Access Compliance Report

Public Rights-of-Way (Curb Ramps)

Intersection ID: 9317	Main Street: JUDSON_AV	Cross Street: W_TRADE_ST	Location: S
ADA ID: 8B468E81217A	Ramp Type: Perp	Initial Pass/Fail: Fail	Overall Compliance: No
		Severity Score: 8.75

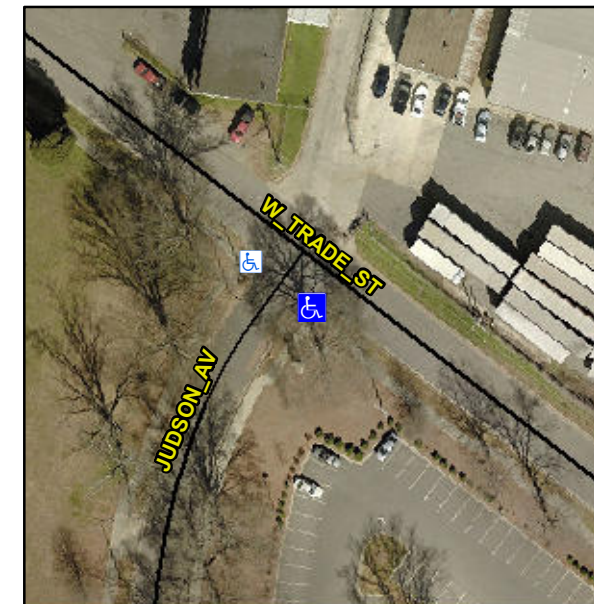
Not Found, R304.5.1

Compliance	Description	Data	Compliance	Description	Data
N/A	Ramp Length (in)	75.0	Yes	Ramp Slope (%)	5.7
No	Ramp Width (in)	46.5	Yes	Ramp XSlope (%)	0.3
N/A	Flare Type LT	N/A	N/A	Flare Type RT	N/A
N/A	Flare Slope LT (%)	N/A	N/A	Flare Slope RT (%)	N/A
N/A	Flare Traversable LT?	N/A	N/A	Flare Traversable RT?	N/A
N/A	Landing Length (in)	N/A	N/A	DWS Provided?	N/A
N/A	Landing Width (in)	N/A	N/A	DWS Contrast?	N/A
N/A	Landing Slope (%)	N/A	N/A	DWS Length (in)	N/A
N/A	Landing X Slope (%)	N/A	N/A	DWS Full Width?	N/A
N/A	Landing Curb? (Y/N)	N/A	N/A	DWS Offset (in)	N/A
N/A	Shared Landing?	N/A			
N/A	Gutter Ponding?	N/A	N/A	Gutter Slope (%)	N/A
N/A	Gutter Lip Ht (in)	0.5	N/A	Gutter X Slope (%)	N/A
N/A	Painted X Walk1?	No	N/A	Painted X Walk2?	N/A
	X Walk 1 Direction	To NW		X Walk 2 Direction	N/A
N/A	X Walk 1 Width (in)	N/A	N/A	X Walk 2 Width (in)	N/A
	X Walk 1 Slope (%)	3.4		X Walk 2 Slope (%)	N/A
	X Walk 1 X Slope (%)	0.3		X Walk 2 X Slope (%)	N/A

Remove & Replace Entire Ramp.
